Planning Commission Staff Report

Consideration of a Preliminary Plat application for the Clegg Canyon subdivision consisting of 18 lots in the Planned Residential Community (PRC-8) zone.

Development Review Committee Minutes

On November 30, 2020 revised plans were submitted for the Clegg Canyon subdivision consisting of 18 lots. The items below include 1) requested changes to the submitted plans, 2) other items required as part of the application and/or 3) informational items regarding city standards.

PRELIMINARY PLAT

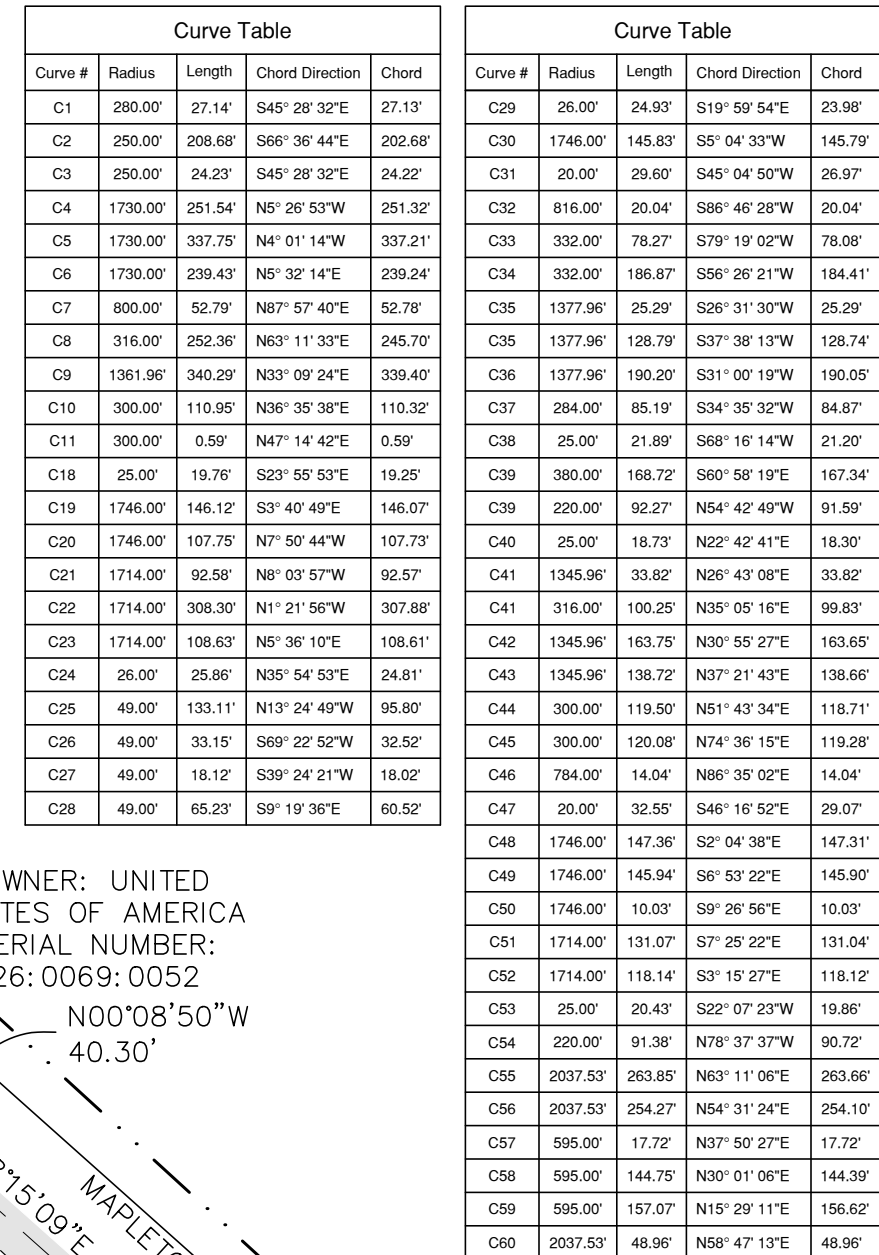
Plat "A"

1. Show location of cluster mailbox. The box should not be on 400 N.
2. Adjust property line to the back of the swale on Maple Canyon Road.

CLEGG CANYON PLAT "A"
MIKE NEMELKA
UTILITY PLAN - POND

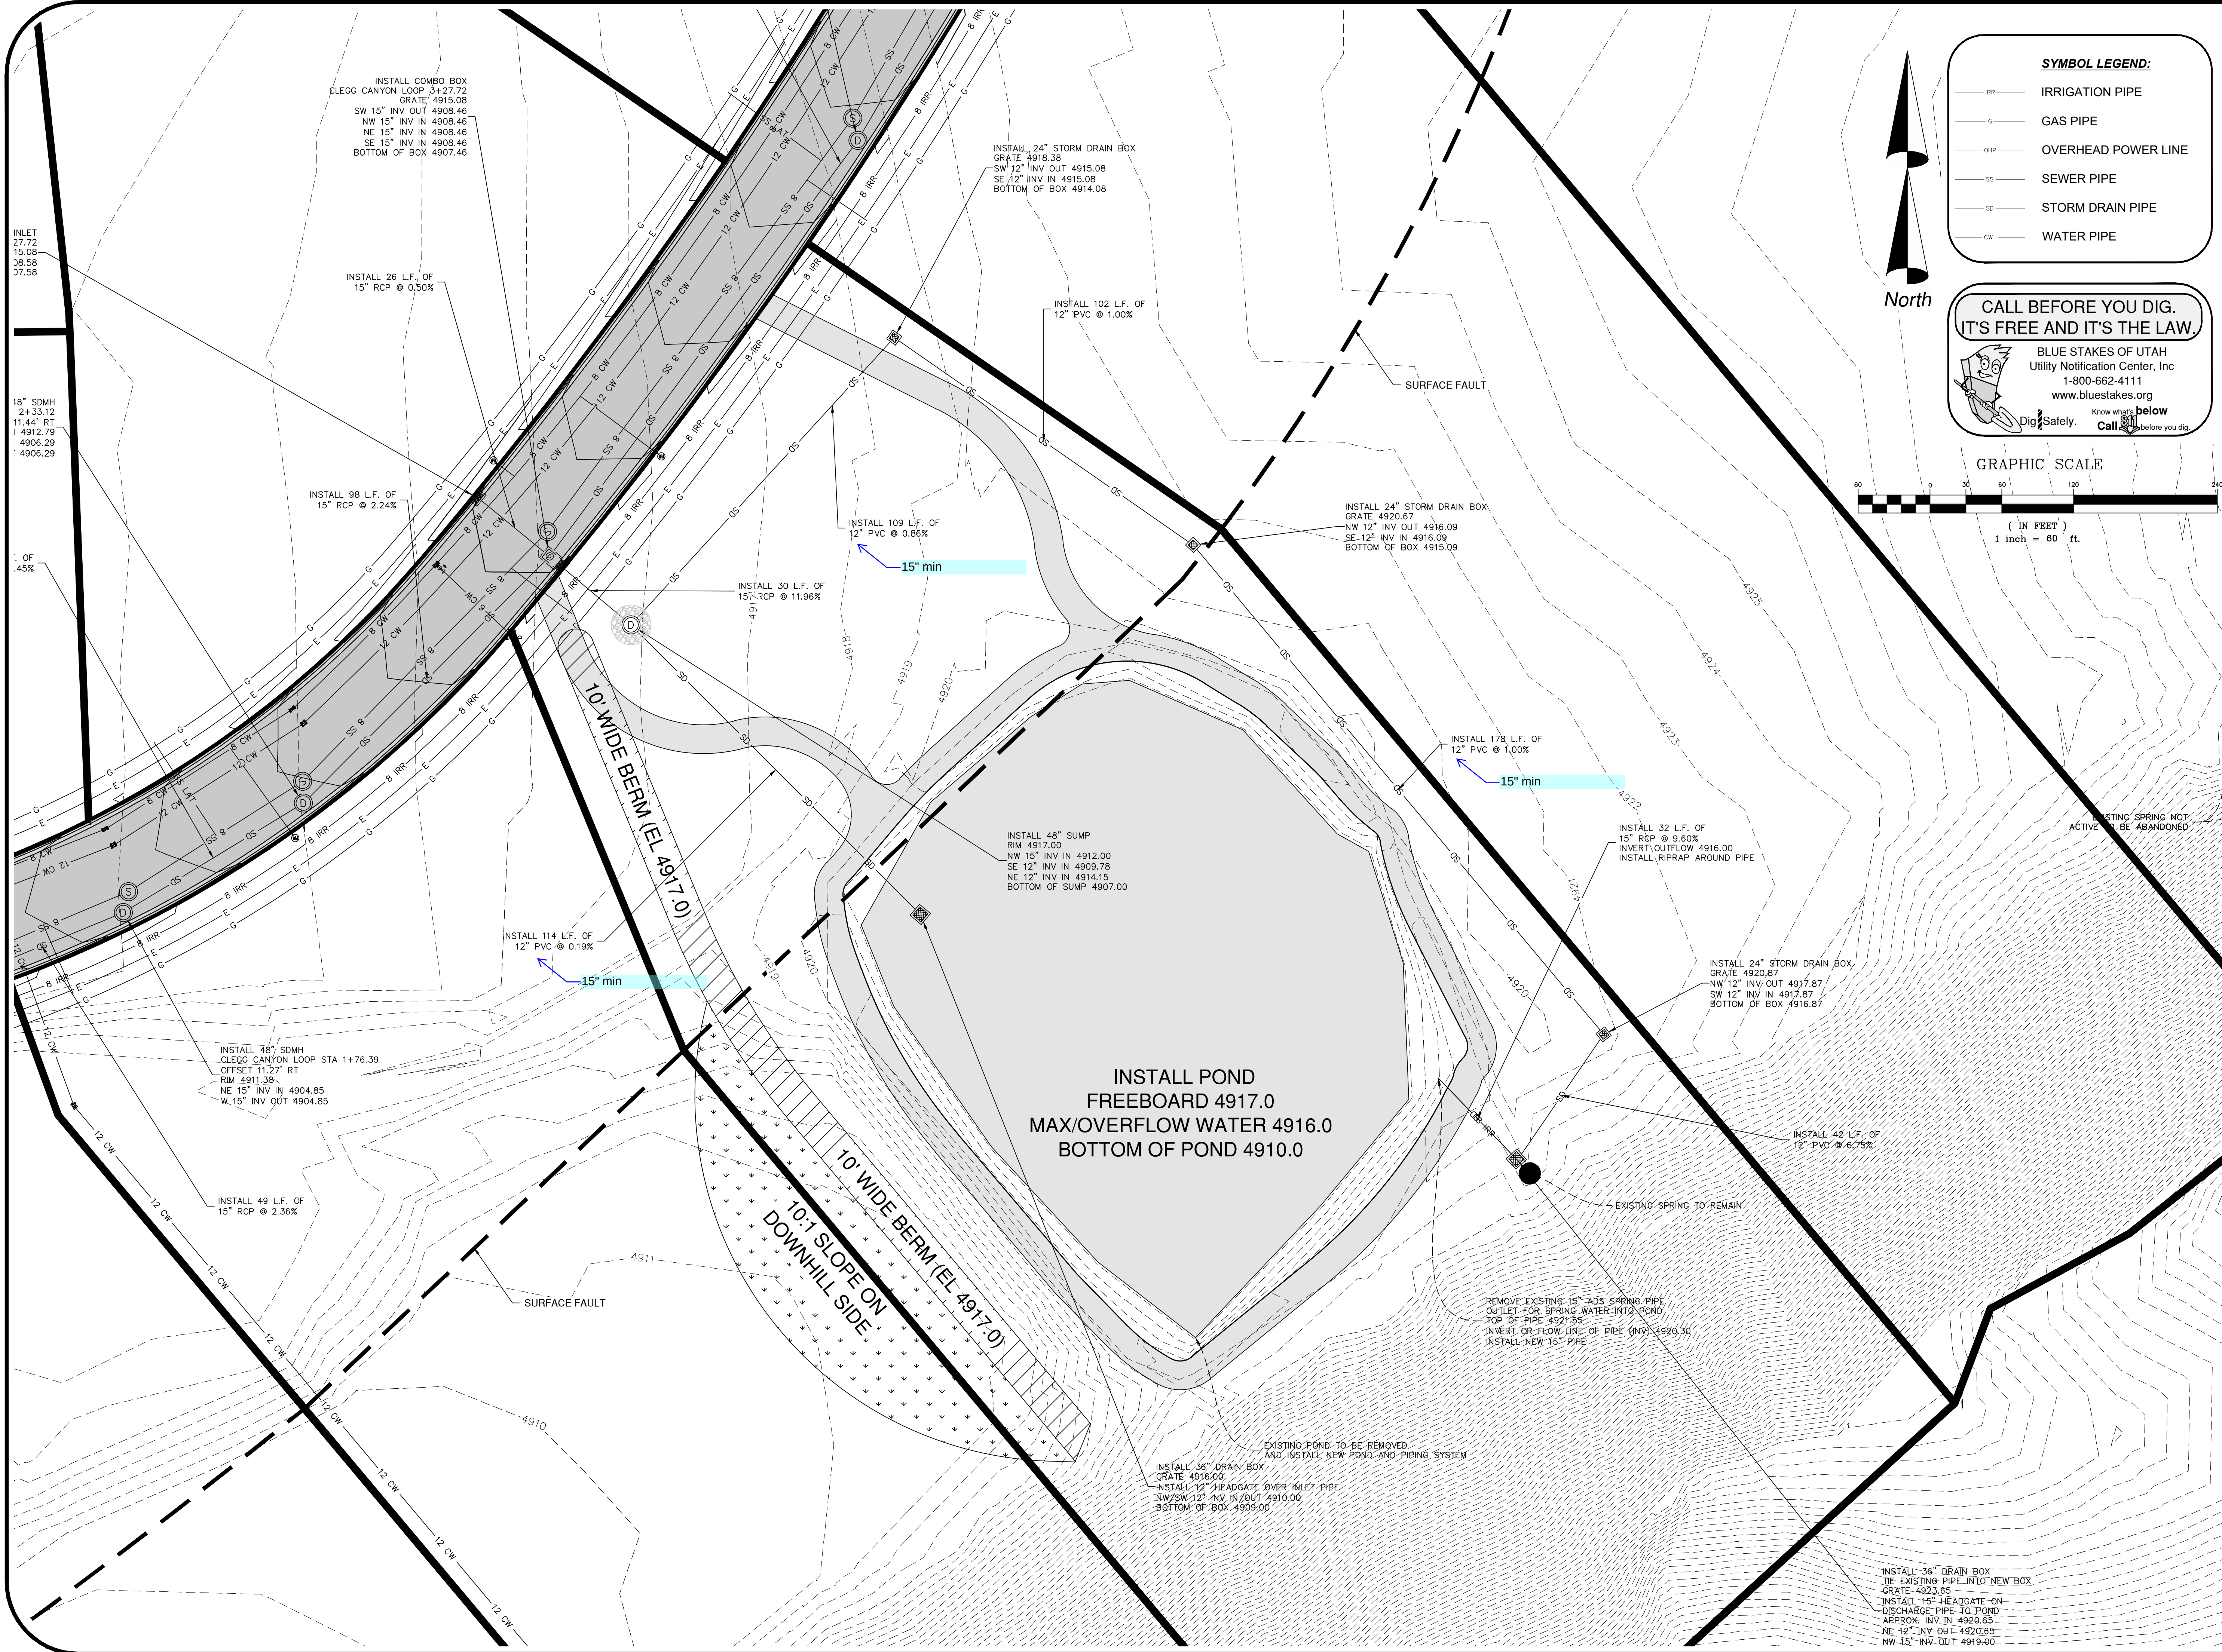
C4.5 Utility Plan – Pond

1. Minimum SD pipe size is 15"
